SOUTHEASTERN DISTRICT HEALTH DEPARTMENT  
INDIVIDUAL SEWAGE DISPOSAL INSTALLATION PERMIT

Permit No. \_\_\_\_\_ Date May 15, 1977  
 Installation for Clifford Traughber at N 1/2 corner on east line of Sec 8 T. 65 R. 34E  
(Name) (Legal description of property)  
 Address of Installation 1/4 mi South of Philitia - Chubbuck Rd intersection on W side of road  
 No. Living Units 1 Bedrooms 4 People Served 3 Water Supply--Private  Public \_\_\_\_\_ Applicant is: Owner  Contractor \_\_\_\_\_ Other \_\_\_\_\_  
 FHA \_\_\_\_\_ FARM HOME \_\_\_\_\_ VA \_\_\_\_\_ CONV.  EXISTING \_\_\_\_\_ NO. \_\_\_\_\_  
 Septic Tank 1000 gal. Perc. Rate 41 Min./in. Min. Depth to Ground Water 40 ft.  
 Effluent Disposal: Effective Area Required 240-280 sq. ft. Soil System: Soil Profile gravel at 5'  
 Field Drain \_\_\_\_\_ Absorption Bed \_\_\_\_\_ Standard \_\_\_\_\_ Modified \_\_\_\_\_ Seepage Pit  Dimensions 8' x 11'

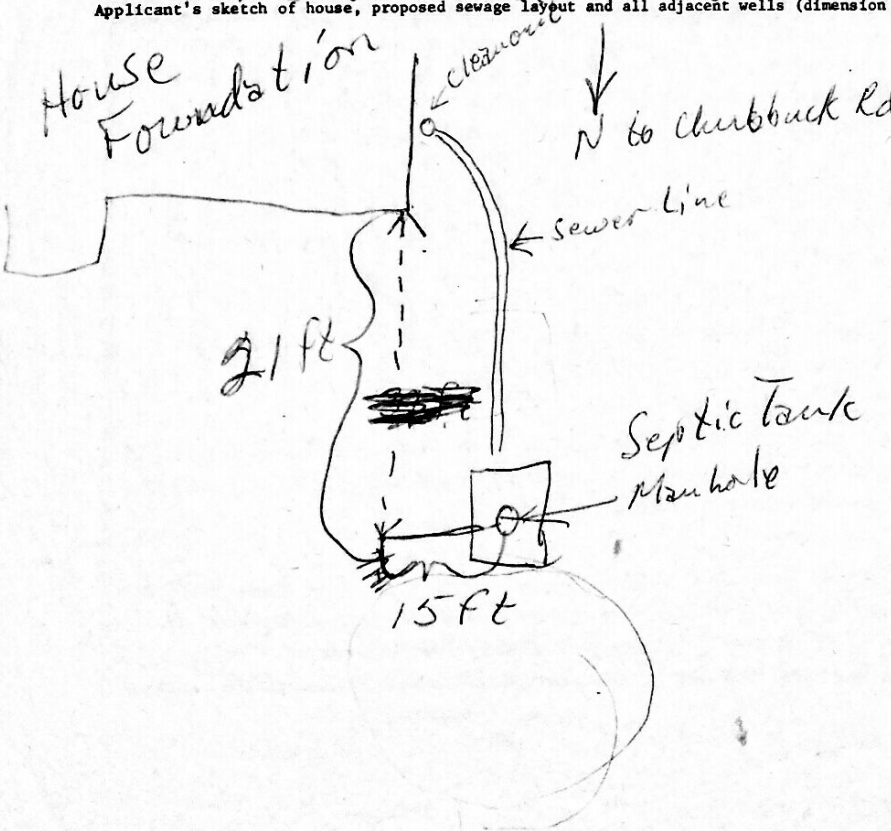
Remarks Septic Tank is placed on edge of seepage pit; also  
sewer line to tank needs to be re-grouted.  
 Applicant's sketch of house, proposed sewage layout and all adjacent wells (dimension between all components) --

System was re-inspected  
 10 Aug 77. Septic Tank  
 was moved 18 ft  
 closer to the house.  
 From 39 ft away to  
 21 ft away. It was  
 freshly grouted.  
 System now meets  
 standards and is  
 approved. Jack B.
